Addendum No. 1

REBID TRUCKEE CANYON WATER SYSTEM EXPANSION

PWP Bid No. WA-2016-158

May 31, 2016

SHEET NUMBER
M101
 27 OF 53

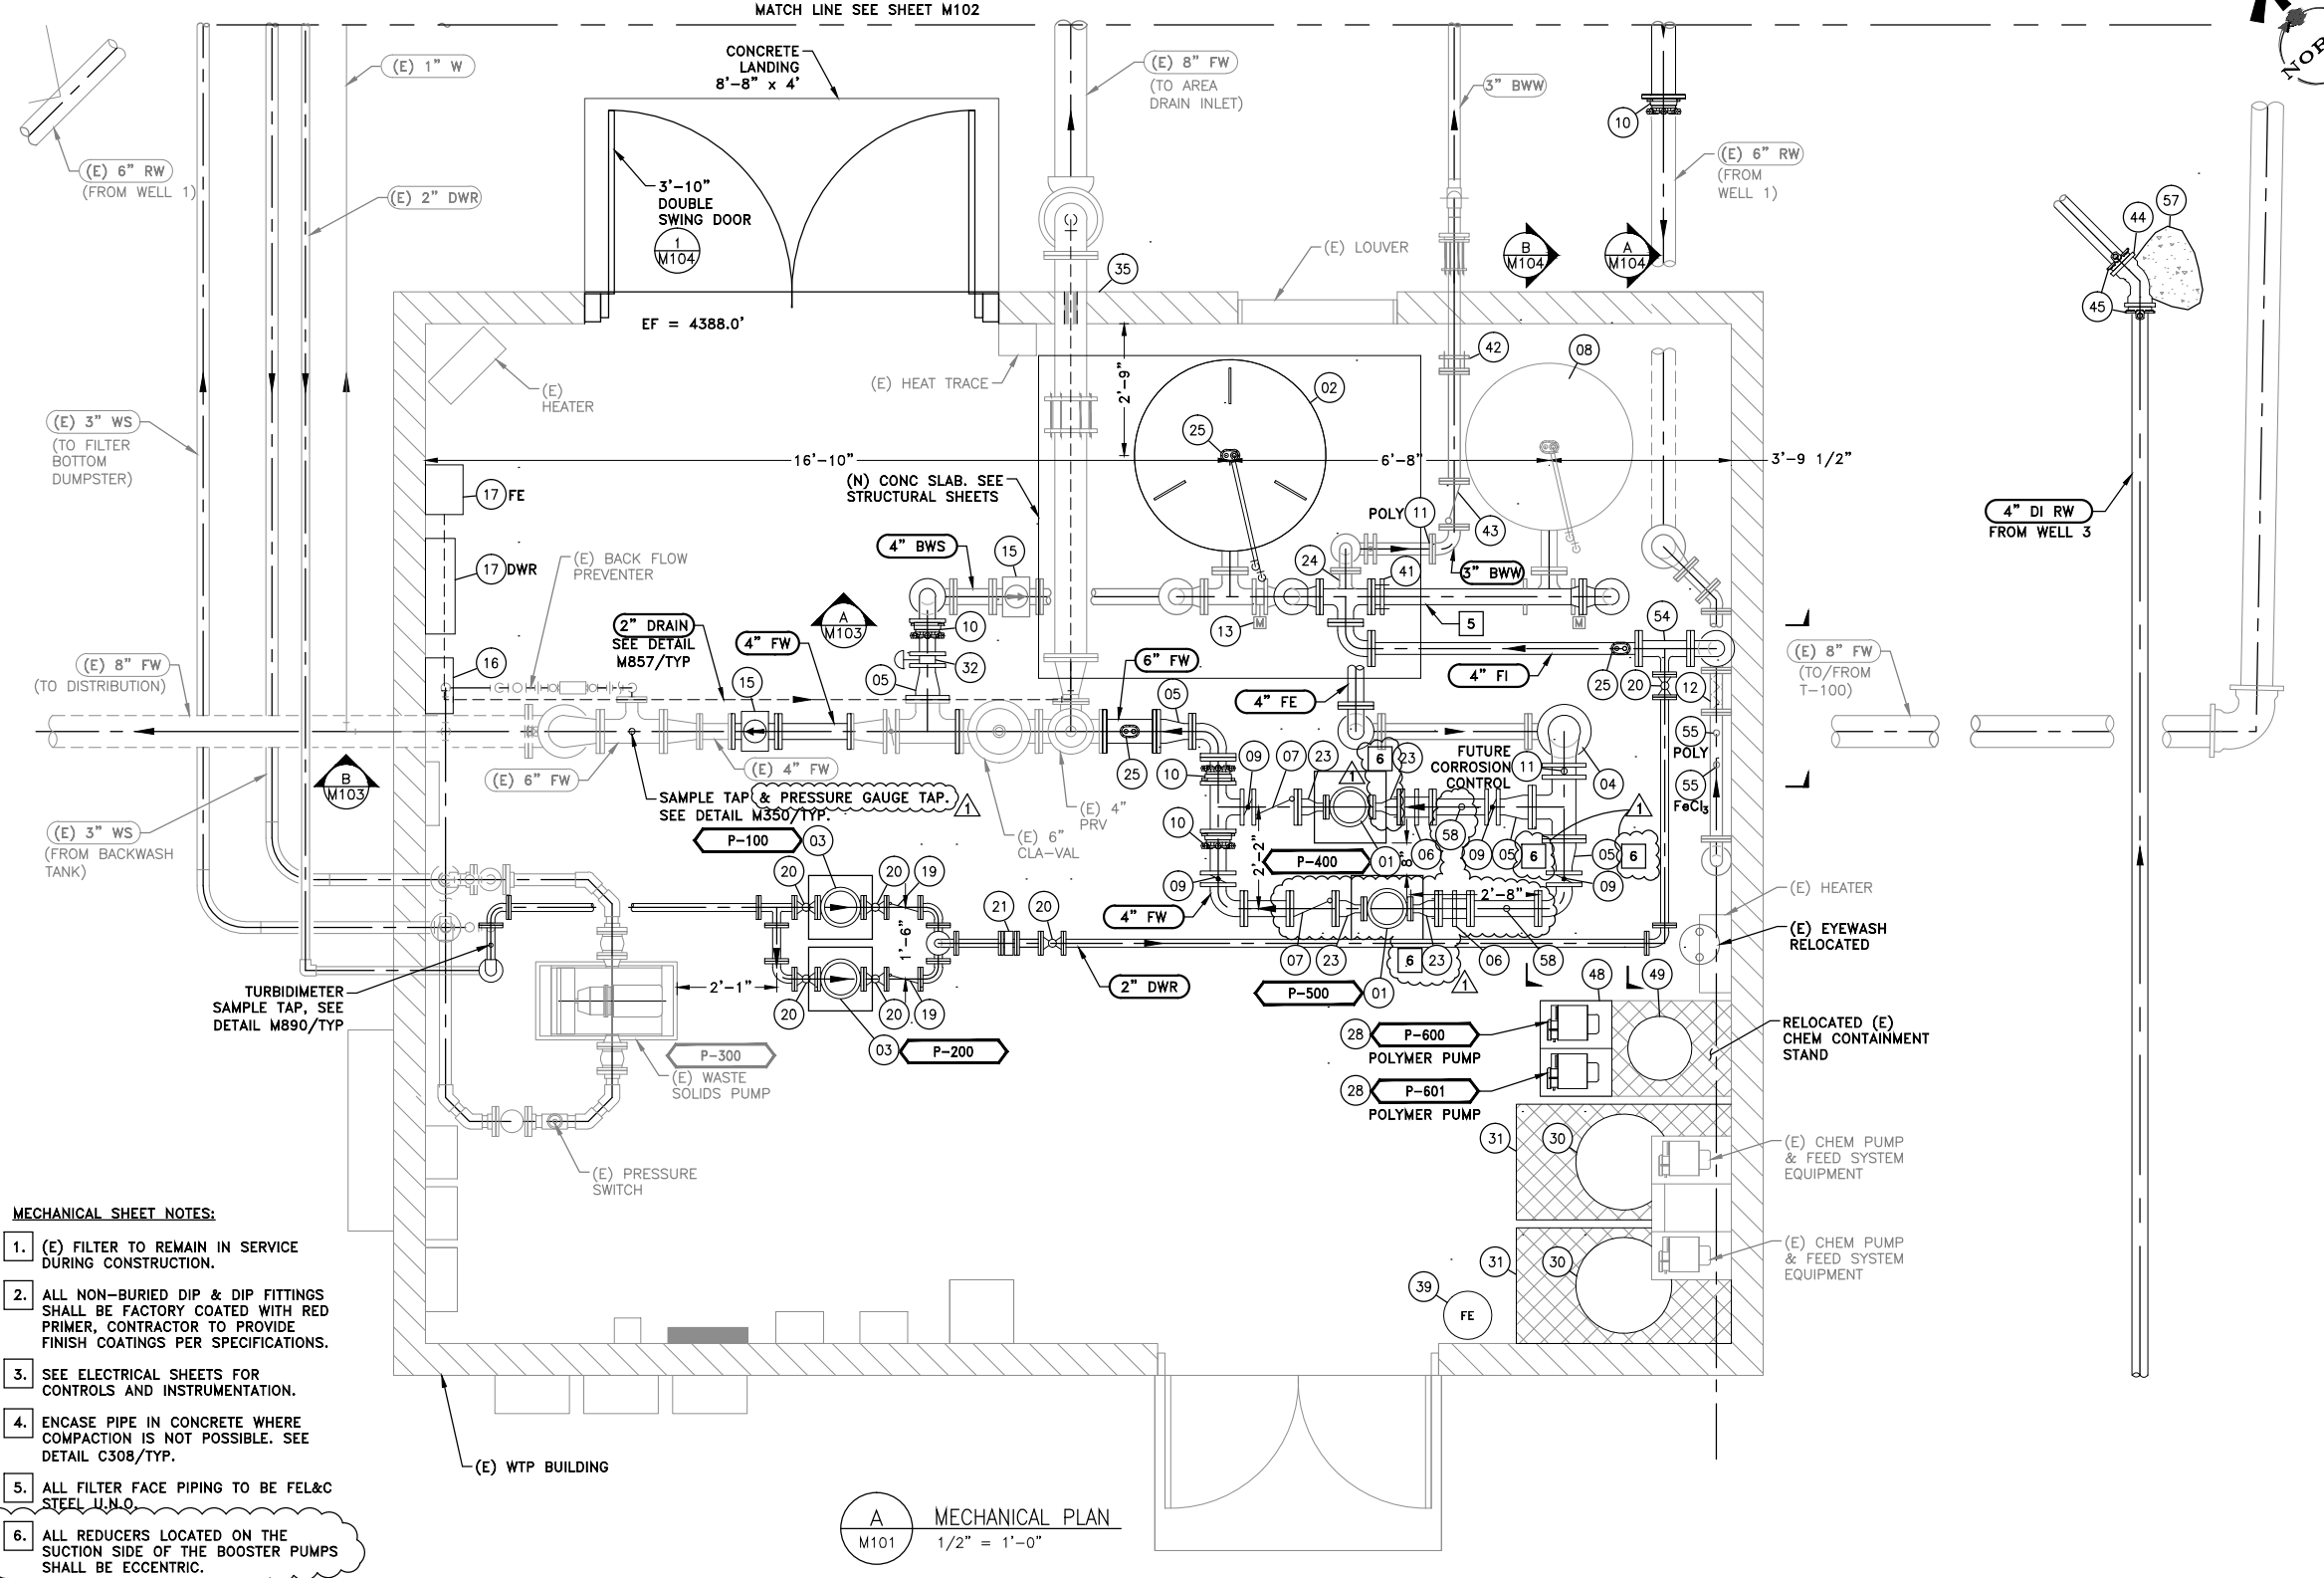
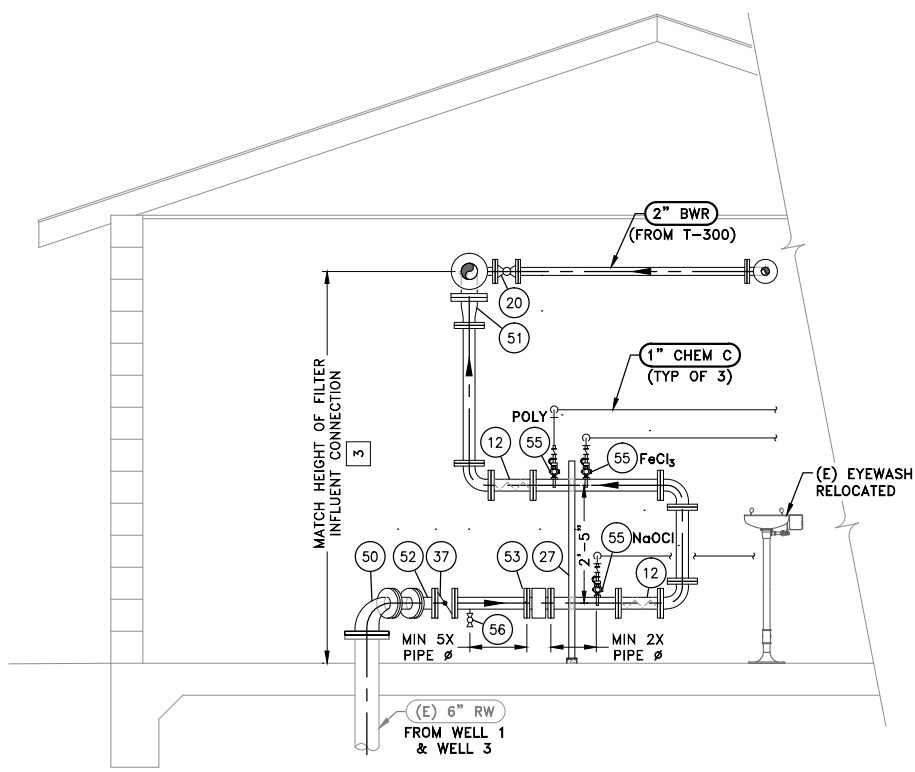
Sheet Number	Page(s)	Description of amendment
M101	27	Please see attached M101 for changes to the booster pump manifold including the addition of pressure gauge taps and eccentric reducers on the suction side of the booster pumps.
M104	30	Please see attached M10 for changes to the booster pump manifold including the installation of eccentric reducers on the suction side of the booster pumps.
E002	36	Manual transfer switch replaced with automatic transfer switch. Please see attached E002 for automatic transfer switch model.
E030	40	The enclosure specified in note 2 of detail B/E030 shall be rated for 600A.
E050	42	Please see attached E050 for the location of the 600A meter main panel.
E051	43	Please see attached E051 for changes to the control panel, starter panel and bill of materials.

- MECHANICAL SHEET NOTES:**
- (E) FILTER TO REMAIN IN SERVICE DURING CONSTRUCTION.
 - ALL NON-BURIED DIP & DIP FITTINGS SHALL BE FACTORY COATED WITH RED PRIMER, CONTRACTOR TO PROVIDE FINISH COATINGS PER SPECIFICATIONS.
 - SEE ELECTRICAL SHEETS FOR CONTROLS AND INSTRUMENTATION.
 - ENCASE PIPE IN CONCRETE WHERE COMPACTION IS NOT POSSIBLE. SEE DETAIL C308/TYP.
 - ALL FILTER FACE PIPING TO BE FEL&C STEEL U.N.O.
 - ALL REDUCERS LOCATED ON THE SUCTION SIDE OF THE BOOSTER PUMPS SHALL BE ECCENTRIC.

E002

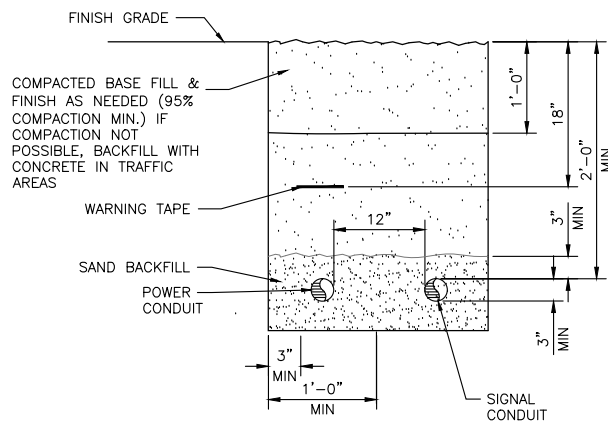
Question No. 2: Drawing E001 Panel HA shows “ main breaker size 600amps” Drawing E002 Panel HA shows “ MLO” main lug only. Will it be 600a main breaker or MLO ?

Question No. 3: May we please have a spec for the manual transfer switch?

Response to Question No. 2: Panel HA is MLO, the CB value noted on E001 is for load calculation purpose only.

Response to Question No. 3: Transfer Switch shall be 600A 277/480V 4pole by GE Zenith Controls model #ZTG000A00060F-ZEC3R-ZVC70 with MX150 controller.

- NOTE:**
- ① STUB AND CAP CONDUIT WITH PULLROPE INSIDE OF POWER PULL BOX.
 - ② RECONNECT ALL LOADS FROM (E) MINI POWER CENTER TO NEW PANEL LA.
 - ③ RELIABLE PANEL TO "PANEL HB".
 - ④ AUTOMATIC TRANSFER SWITCH. PROVIDE 600A 277/480V 4POLE BY GE ZENITH CONTROLS MODEL #ZTG000A00060F-ZEC3R-ZVC70 WITH MX150 CONTROLLER OR APPROVED EQUIVALENT

SHEET NUMBER
E050
 42 OF 53

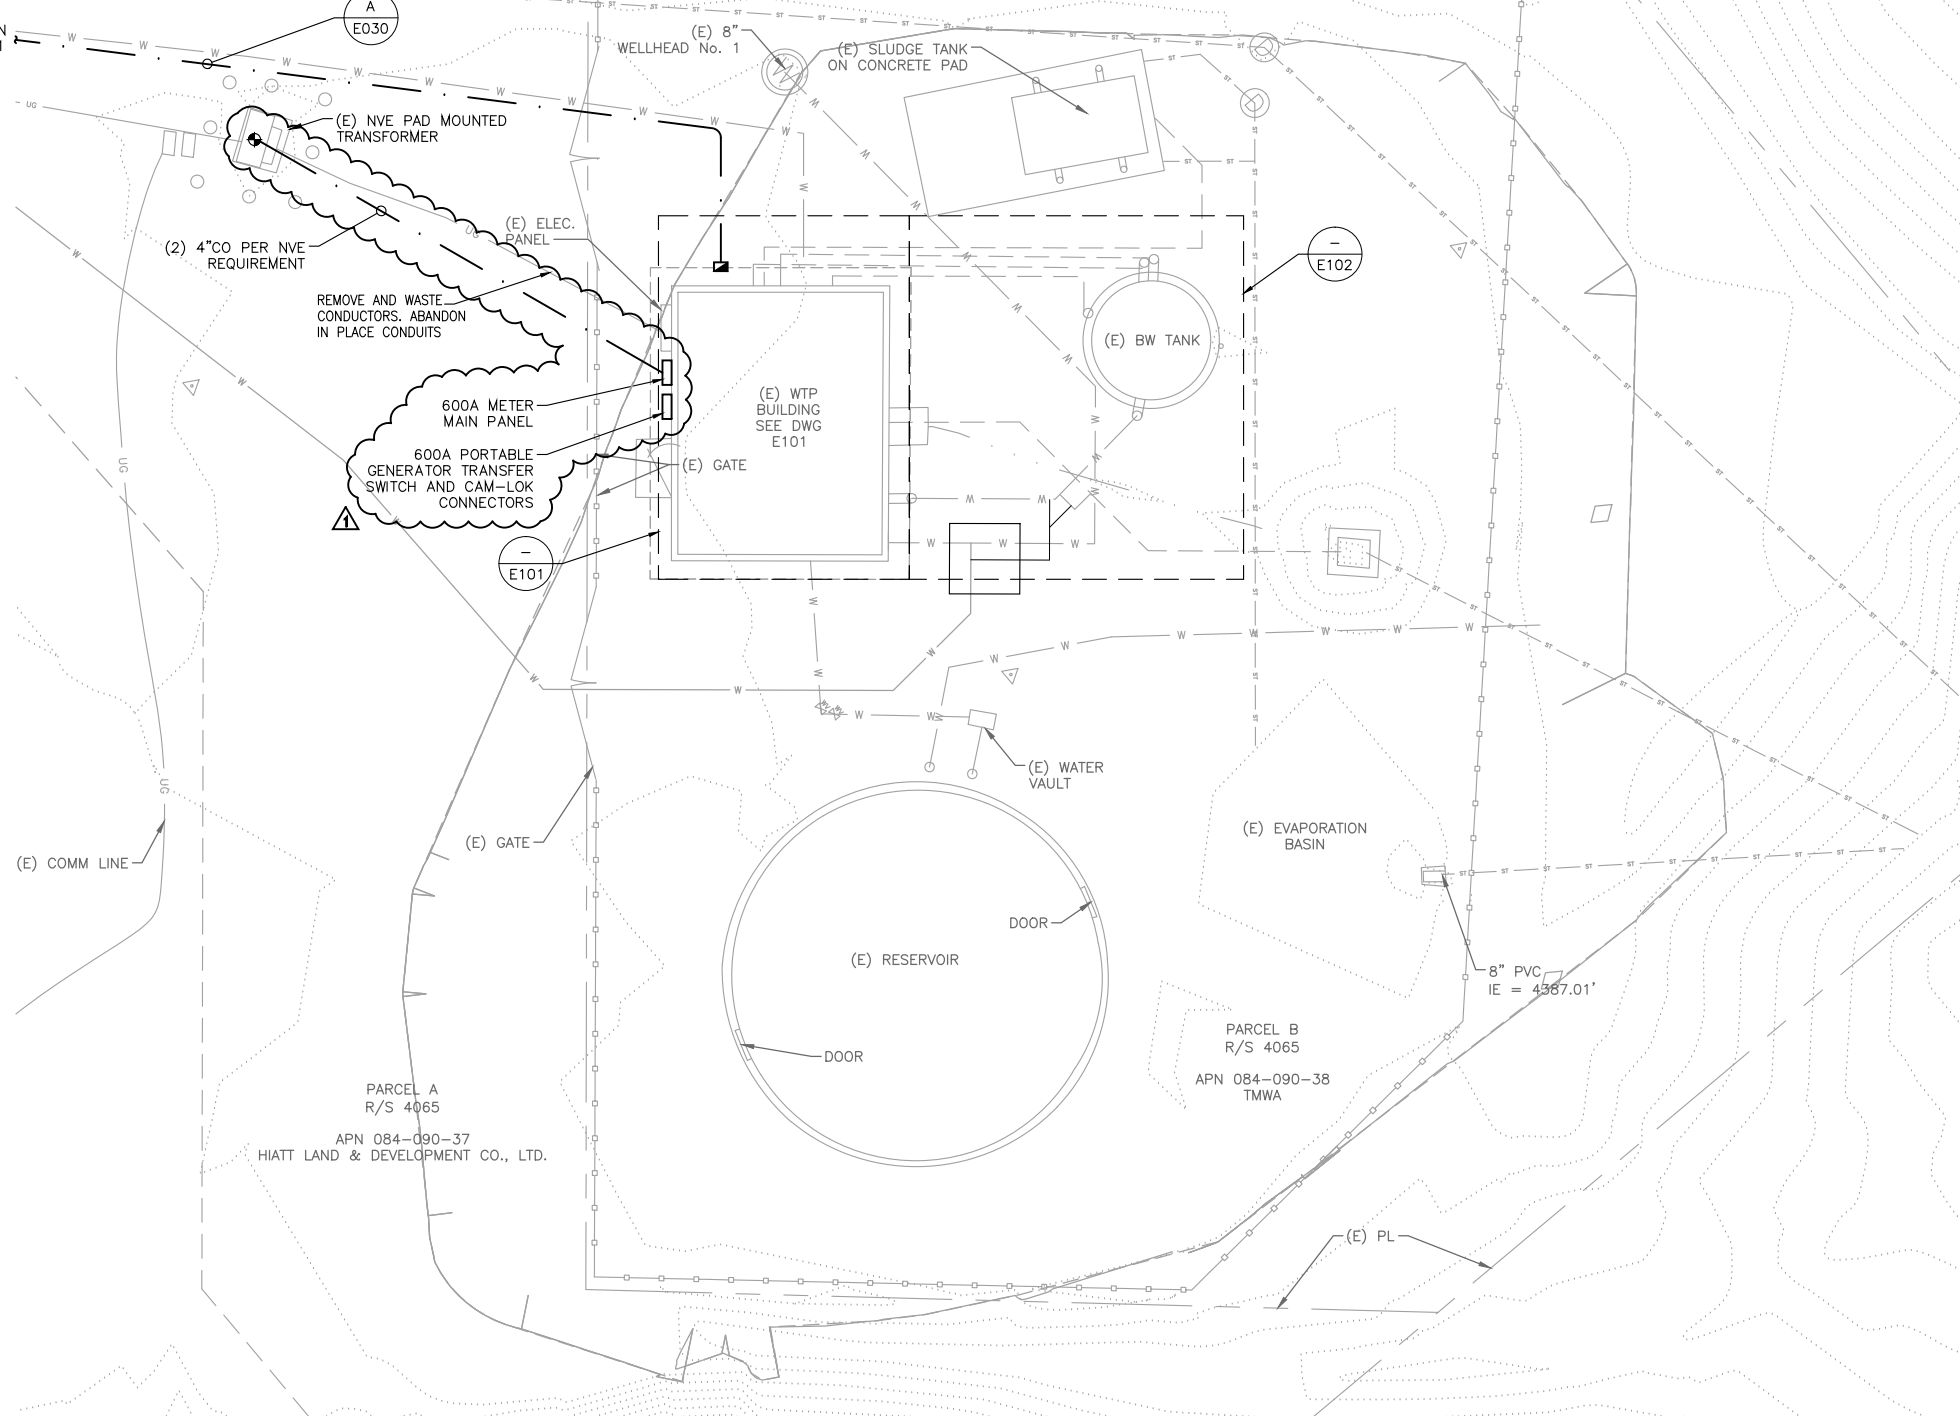
Question No. 4: Drawings E050 and E101 show the 600amp meter main on different exterior walls.

Which one is correct?

Response to Question No. 4: The location of the 600A meter main panel shown on E101 is correct. Corrections to E050 are attached.
